REVIEWED FOR CODE COMPLIANCE DEVELOPMENT SERVICES
 BY: [Signature] DATE: 2/2/00

PROJECT: RWT BUILDING SAN CARLOS BLVD. FT. MYERS, FLORIDA 33909
DEVELOPER: GULF TO BAY CONSTRUCTION, INC. 14370 MCGREGOR BLVD. FT. MYERS, FL. 33909

SD-1

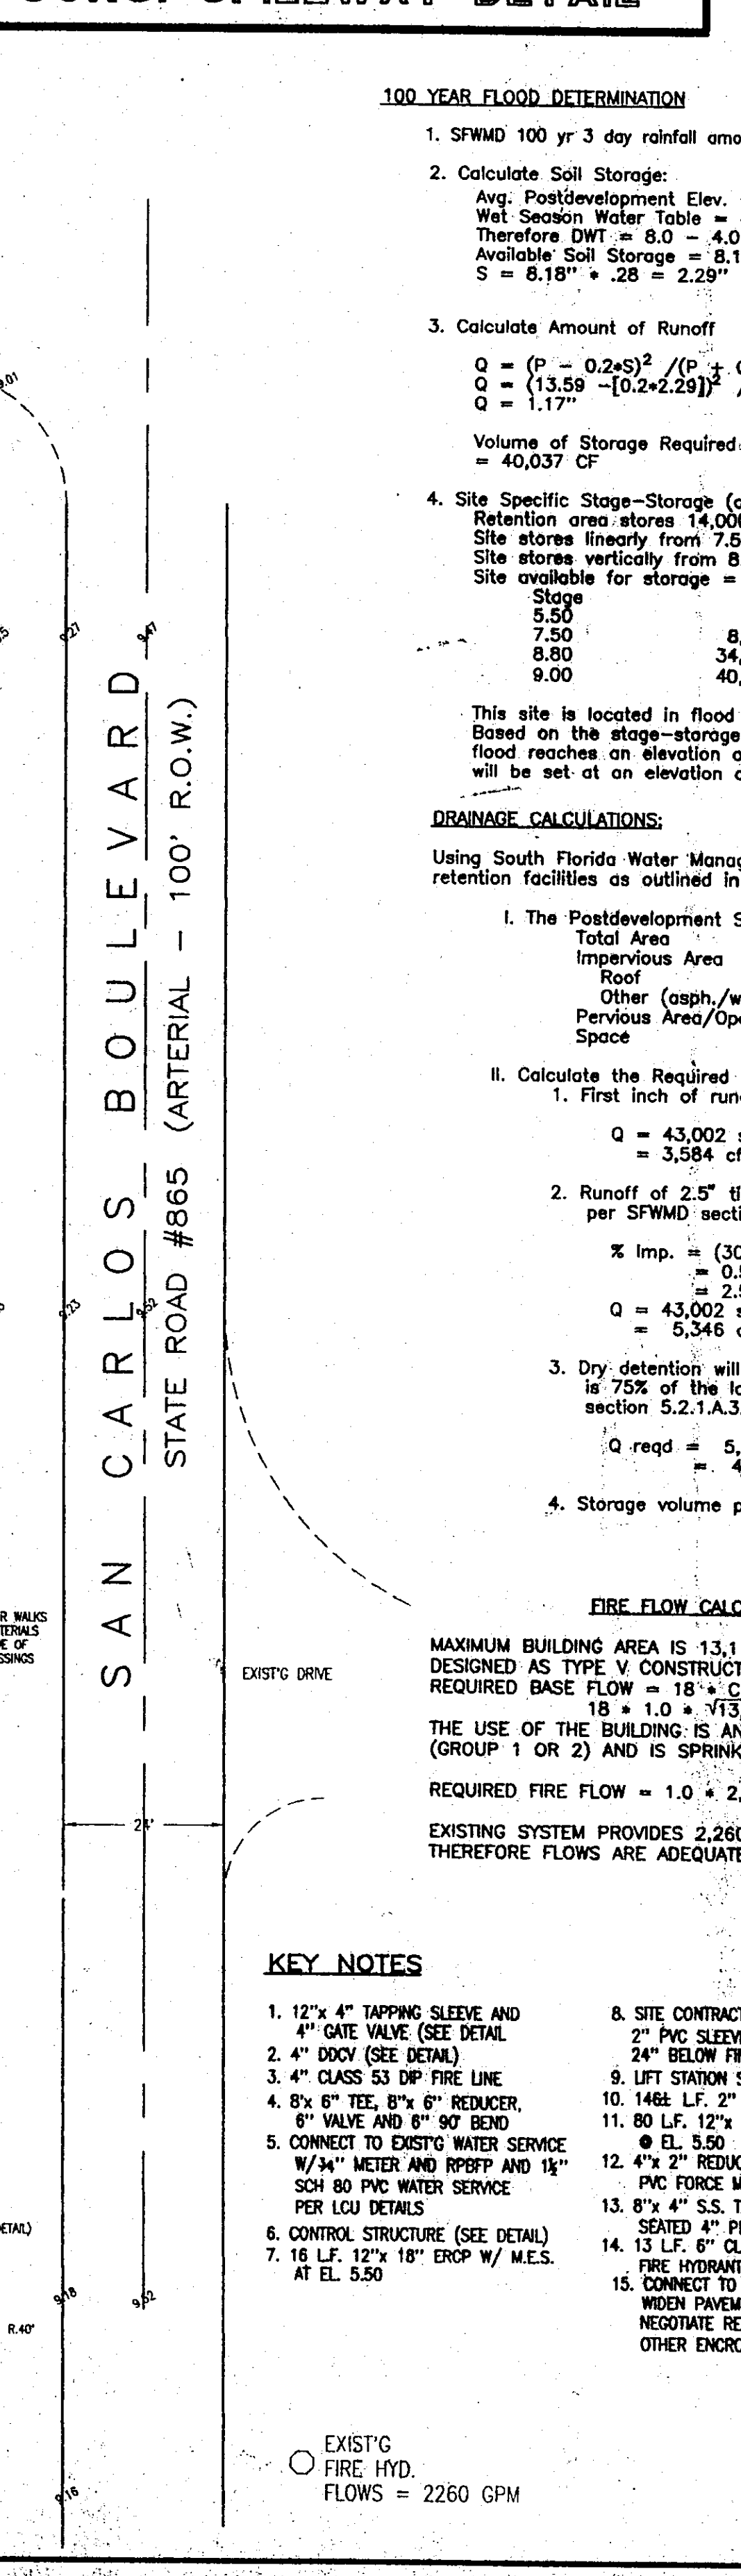
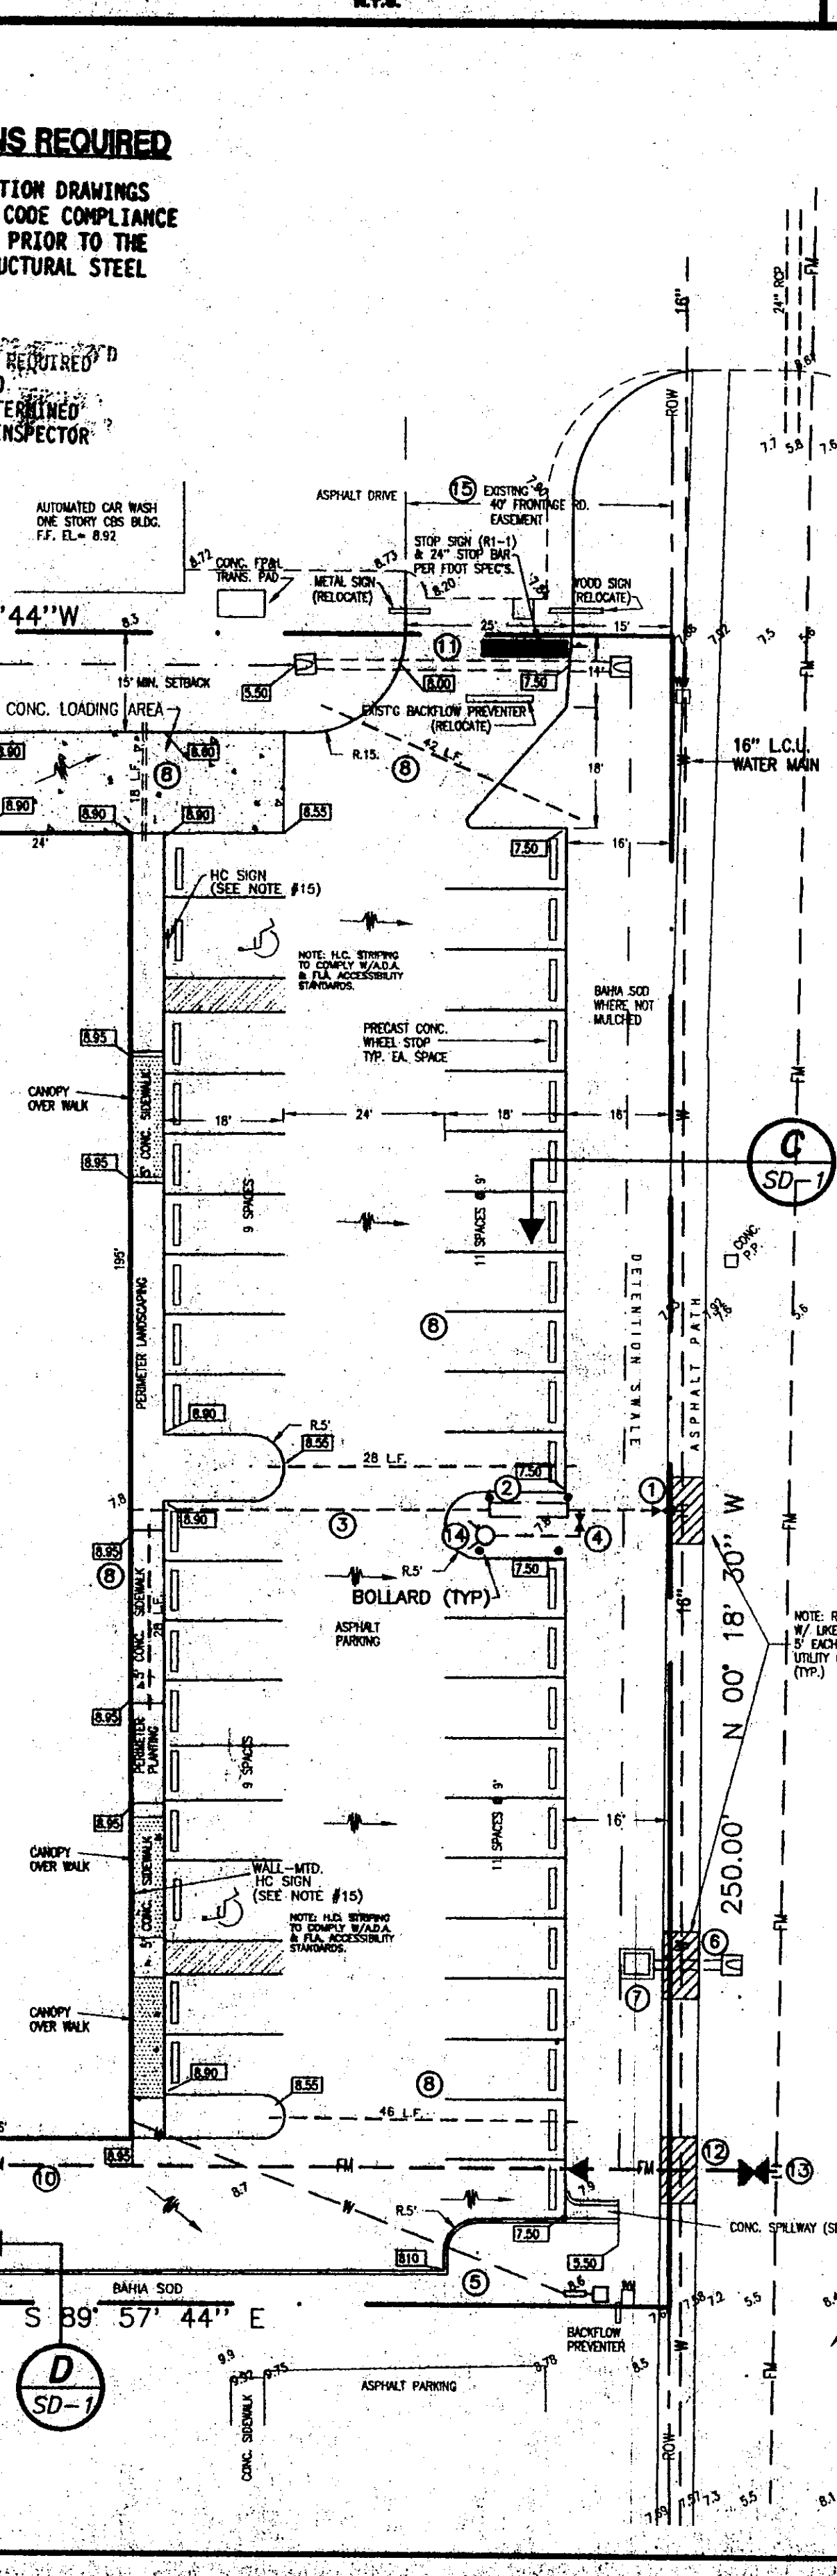
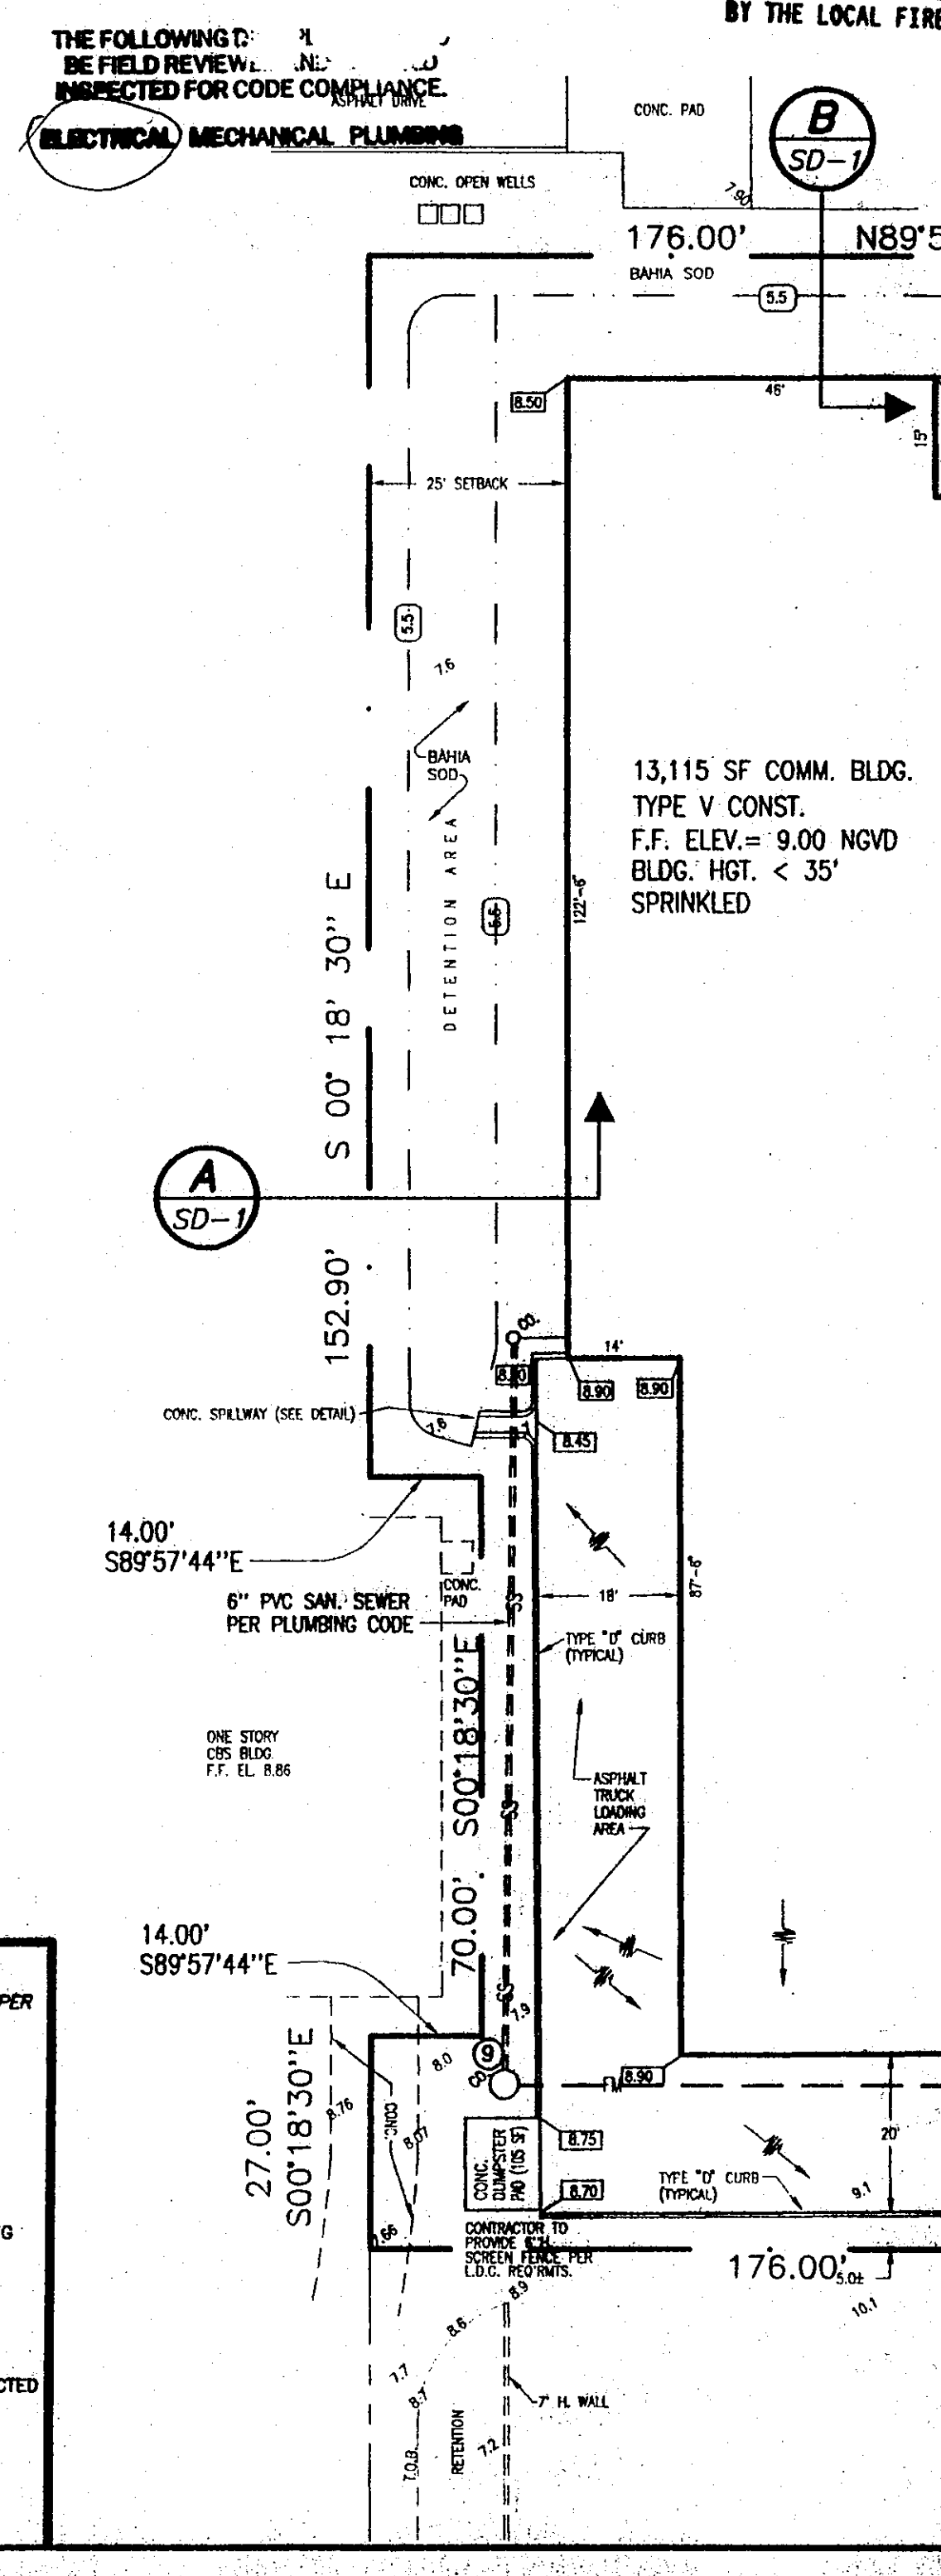
ADDITIONAL PLANS REQUIRED
 METAL BUILDING ERECTION DRAWINGS MUST BE SUBMITTED FOR CODE COMPLIANCE REVIEW AND APPROVAL PRIOR TO THE ERECTION OF ANY STRUCTURAL STEEL

FIRE EXTINGUISHERS REQUIRED PER NFPA 10. PLACEMENT TO BE DETERMINED BY THE LOCAL FIRE INSPECTOR

FIRE DISTRICT INSPECTION REQUIRED Before A Certificate of Occupancy Can be Issued.

THE FOLLOWING MUST BE FIELD REVIEWED AND INSPECTED FOR CODE COMPLIANCE:
 1. ELECTRICAL
 2. MECHANICAL
 3. PLUMBING
